SYNGENE INTERNATIONAL LTD, VELANKANI TECH PARK, ACCESSIBILITY AUDIT REPORT

PREPARED BY SVADHIN SOLUTIONS

GROUND FLOOR, SYNGENE INTERNATIONAL, VTPL – ACCESSIBILITY OVERVIEW

WORK AREA CIRCULATION

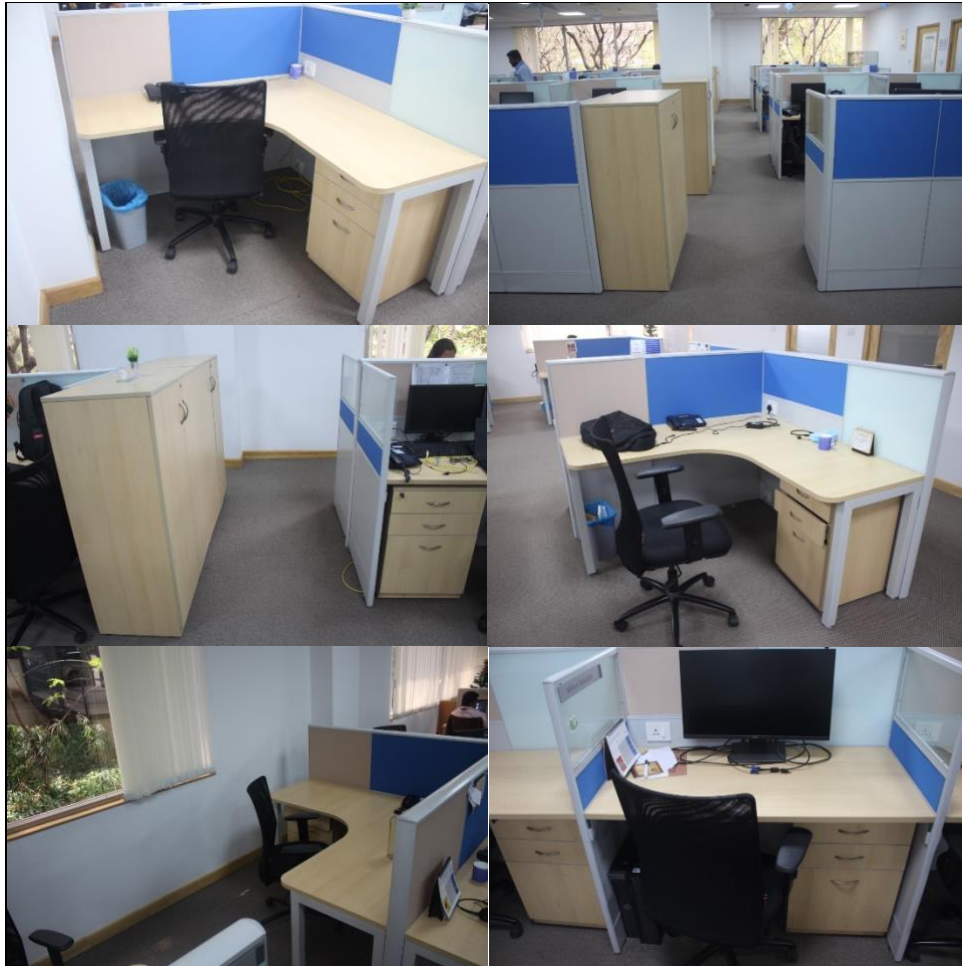
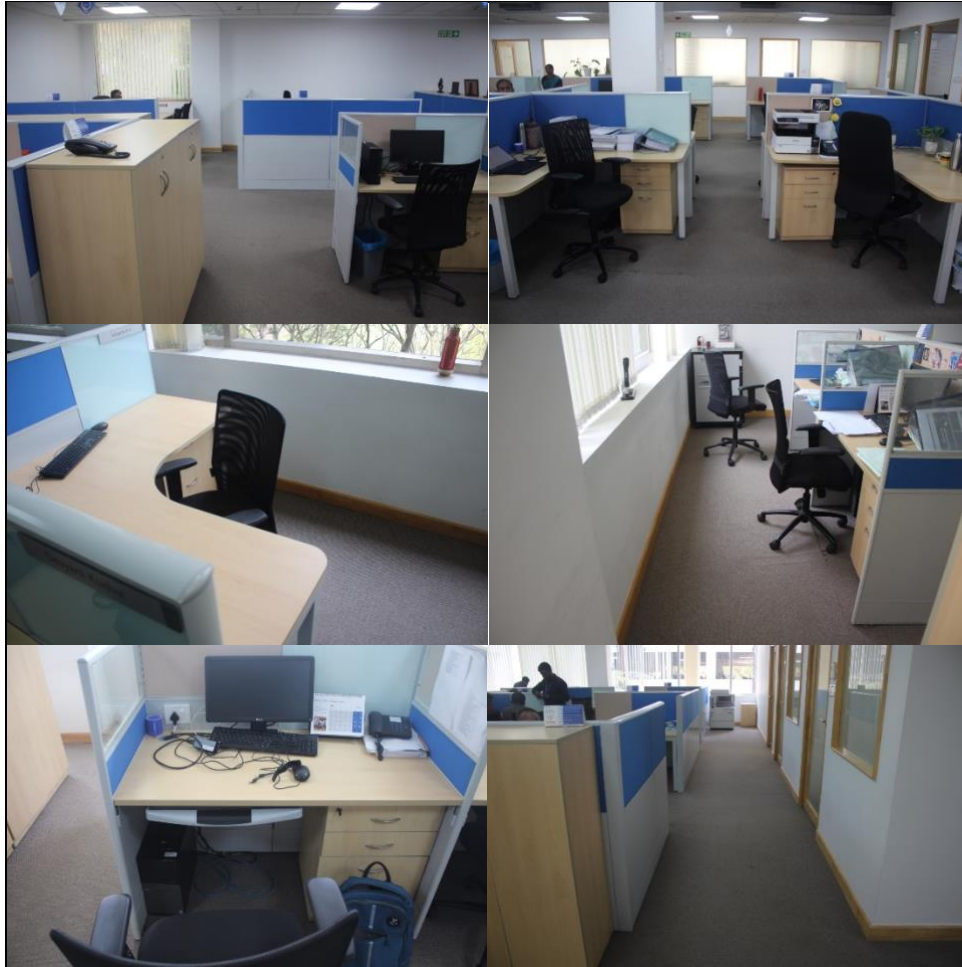
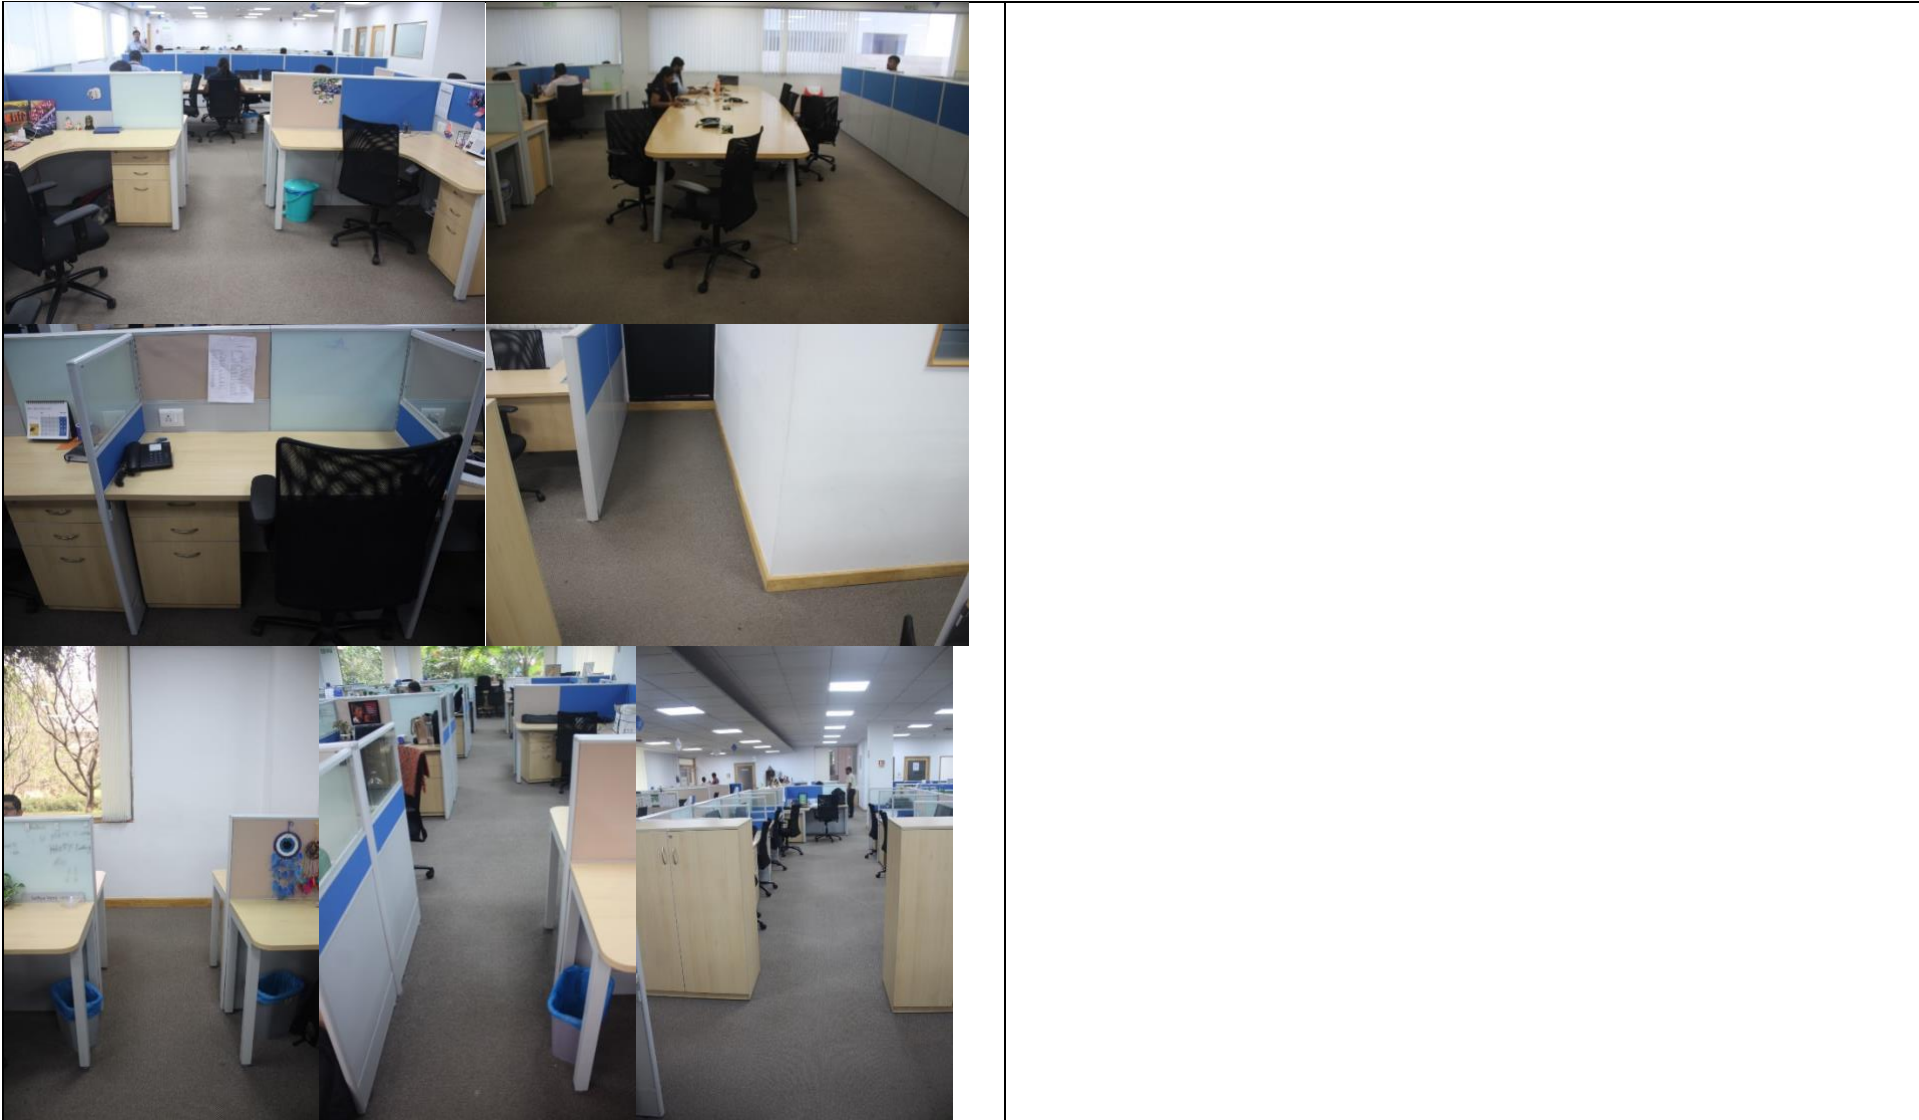
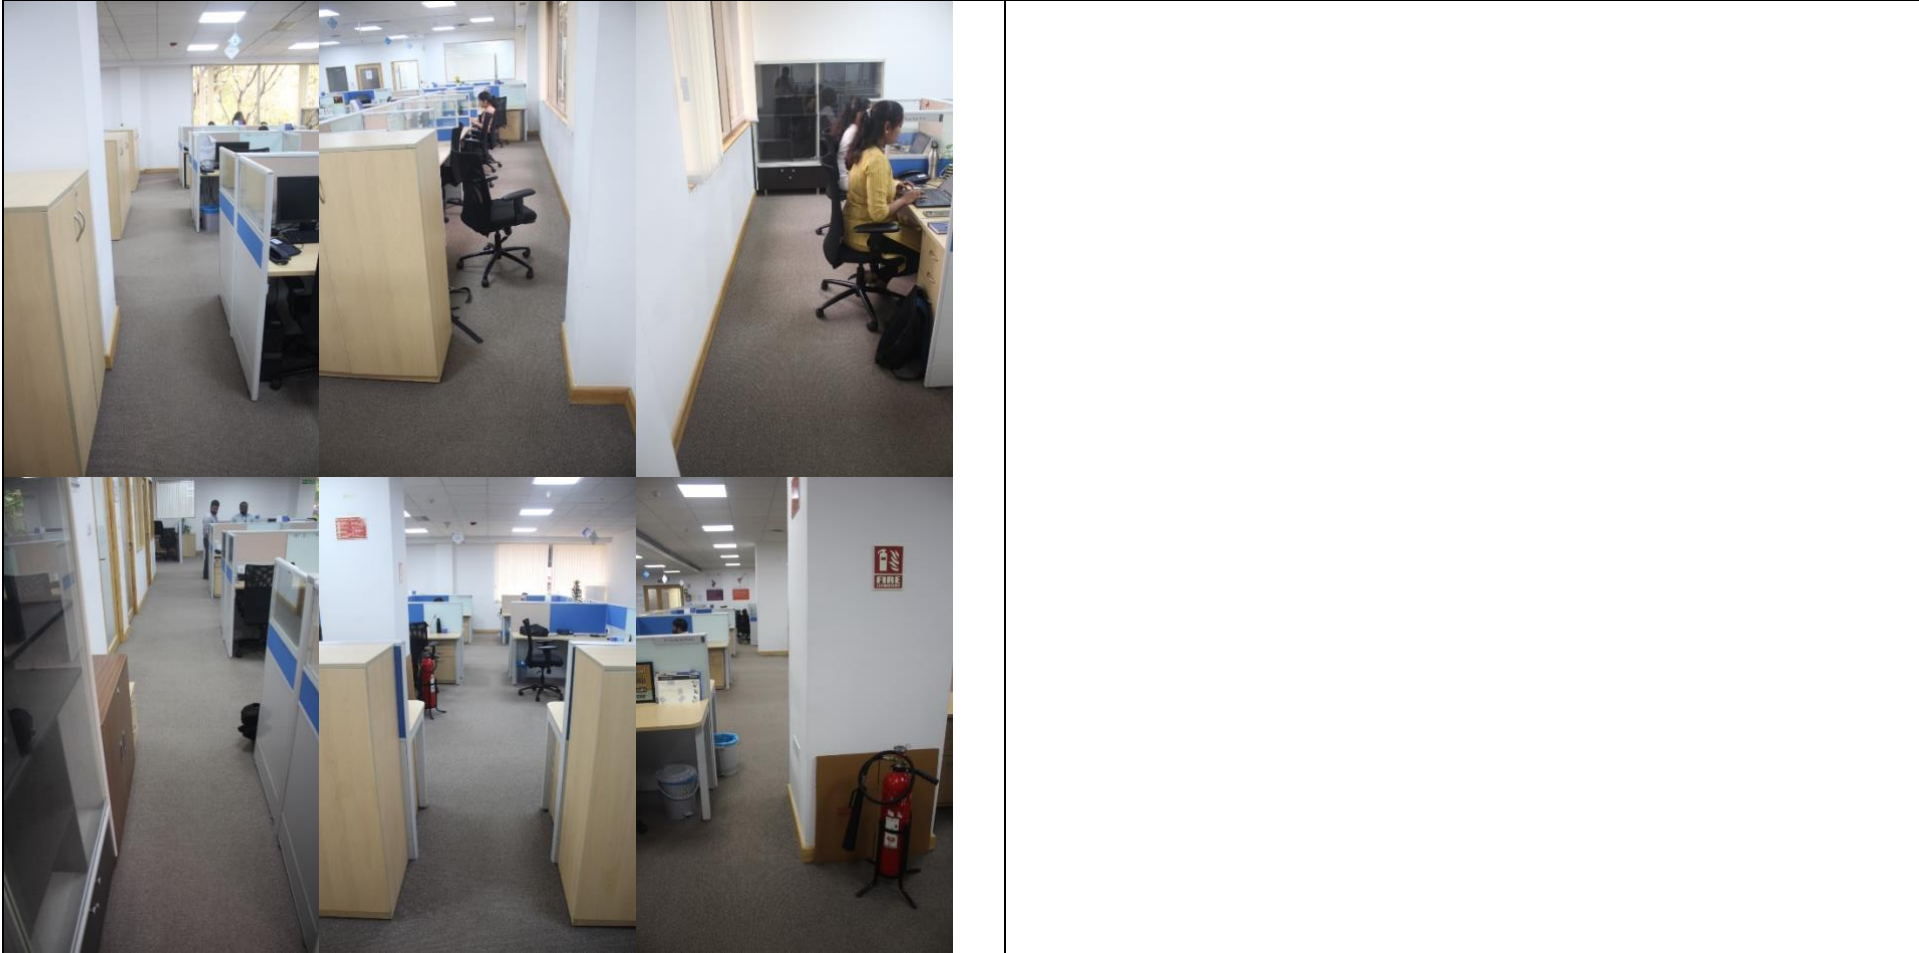
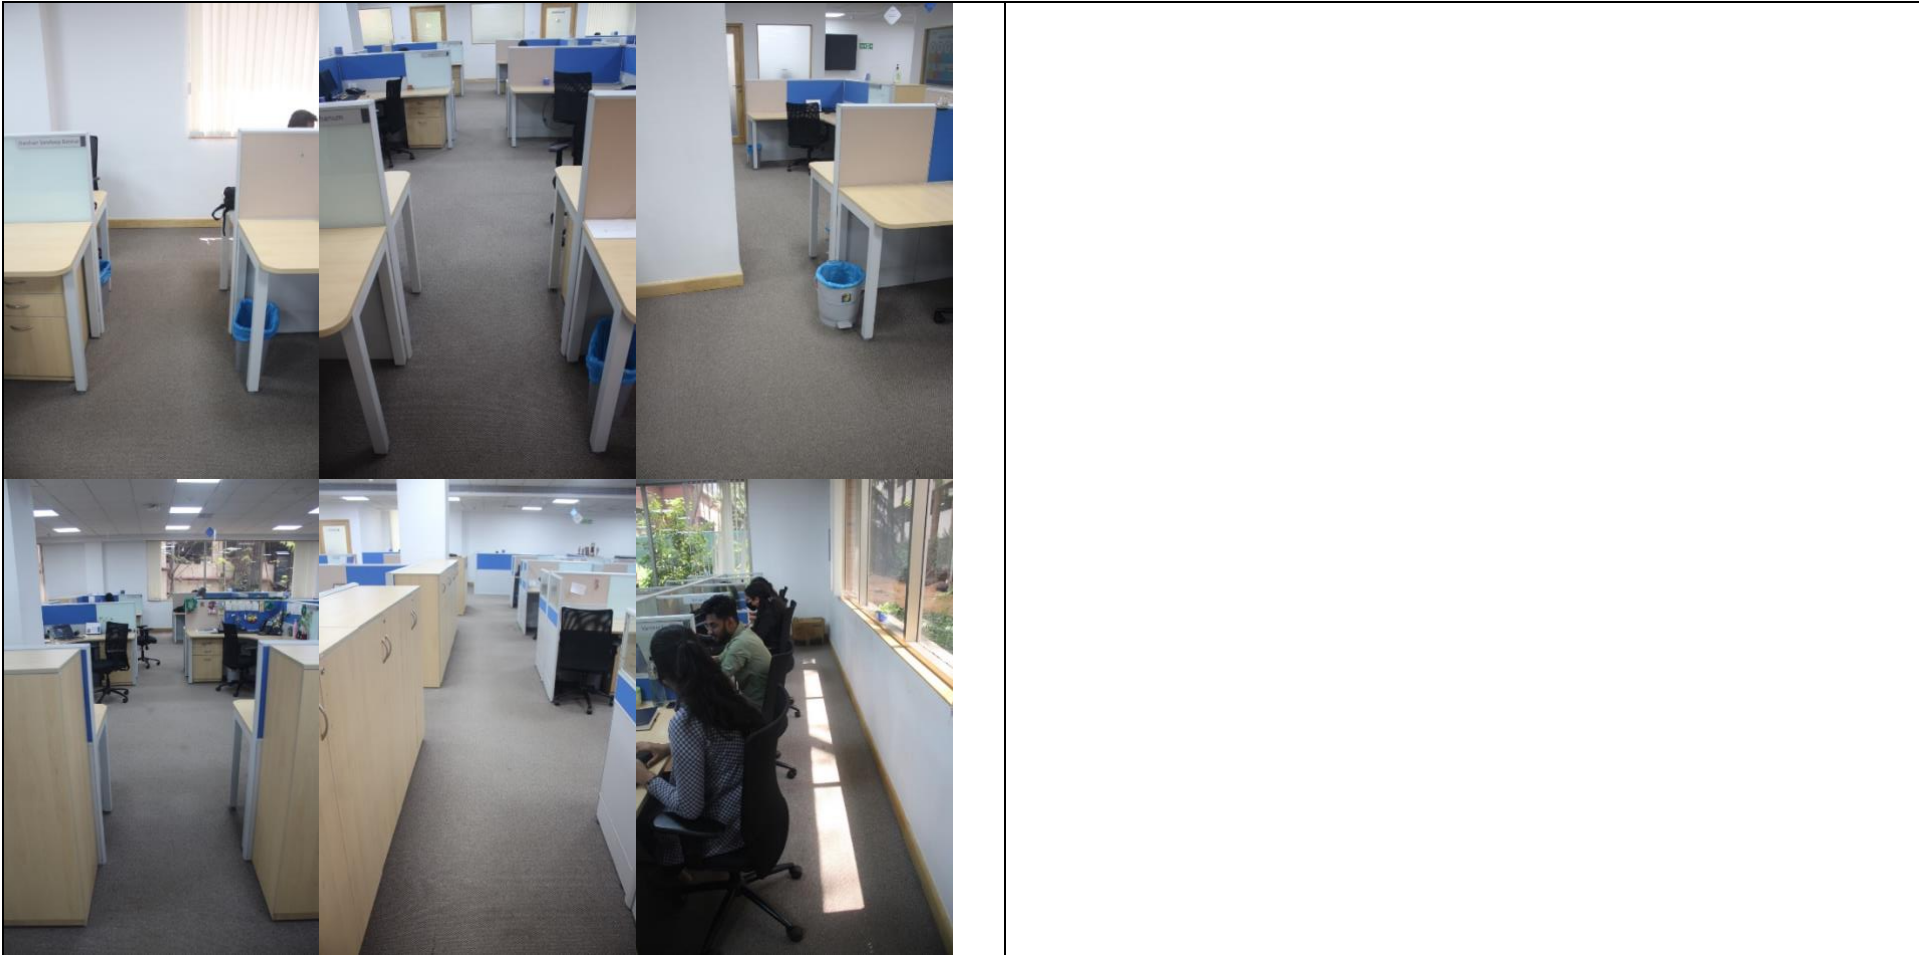
➤ A lot of points in the circulation paths and cubicle entries across the work floors have inaccessible widths as marked in the floor plans which will make the areas beyond these points completely inaccessible for PwDs

- A lot of points in the circulation paths and cubicle entries across the work floors have non-compliant widths and some of the pathways around the work seating in the circulation paths have practically hard to navigate widths as marked in the floor plans and will act as roadblocks for PwDs making these areas practically difficult for PwDs to navigate around

- Most of these inaccessible, hard to navigate and non-compliant circulation path widths and points have been created because of the placement design of the work stations not accommodating movement space required to move in a particular area

- There are multiple seats across the work floors that have inaccessible and/or non-compliant chair clearances as marked in the floor plans and will be inaccessible for certain PwDs

- Some of the work area passages have storage units and/or printers placed that compromise the passage width there as well as compromising access space required for the storage units and the printers

- The linear style workstations have keyboards that compromise knee clearances for wheelchair users making these workstations inaccessible to use
- The workstation storage pedestals as well as storage cabinets are inaccessible for people with certain types of hand impairment because of the locking mechanism and handle type
